## REMARKS

### Summary of Office Action

FIG. 1

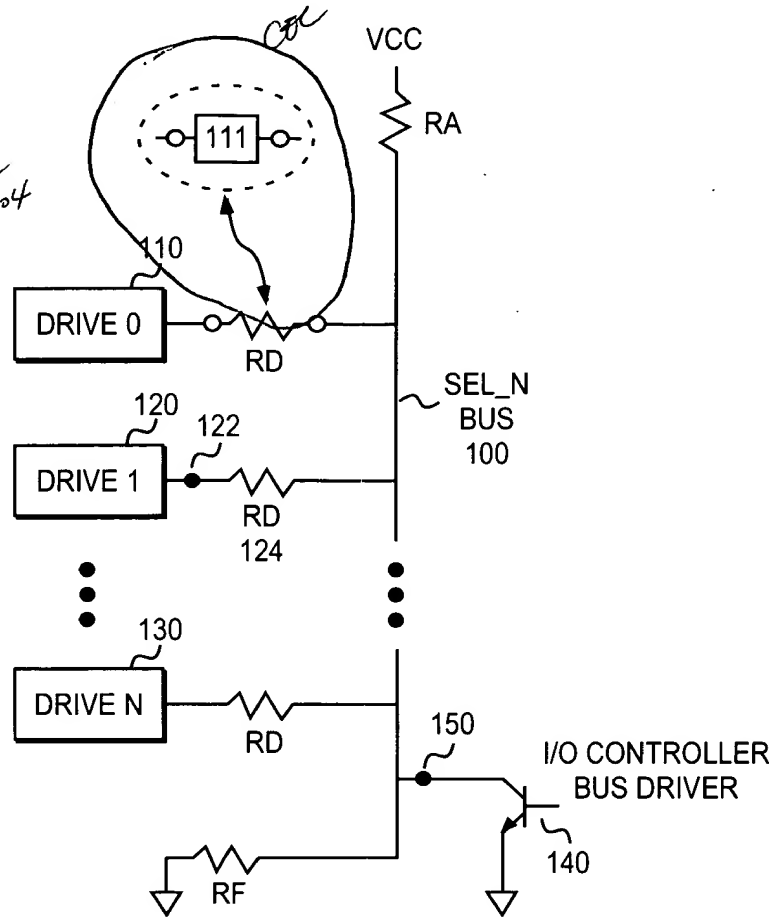
The drawings were also objected to because “they fail to show the isolation circuitry comprising active components as described in the specification”.

Figure 1 has been amended to include a reference to an active component 111. The specification has been amended at page 6 to include a reference to the character reference number 111.

Accompanying this Amendment is a replacement sheet for Figures 1-2 of the drawings. Figure 1 has been amended to illustrate an isolation circuitry comprising an active component 111. The specification has been amended at page 6 to include a reference to the character reference number 111.

FIG. 2

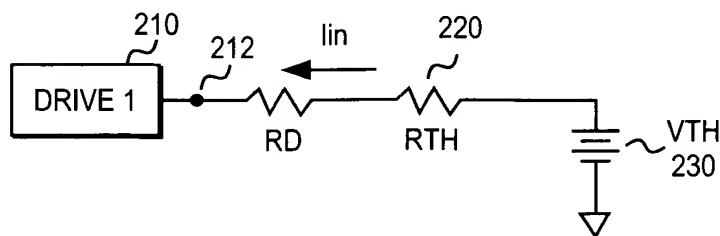
The drawings were objected to because the reference characters 220 and 230 of Figure 2 were not used in the specification (12/17/2003 Office Action, p. 2). As indicated above, the specification has been amended to refer to reference characters 220 and 230.

The specification was amended at page 6, Tables 1 and 2 to correct clerical errors. The specification was amended at page 7 to include reference characters illustrated in Figure 2. The specification was amended at page 10 to correct references to reference characters of Figure 5.
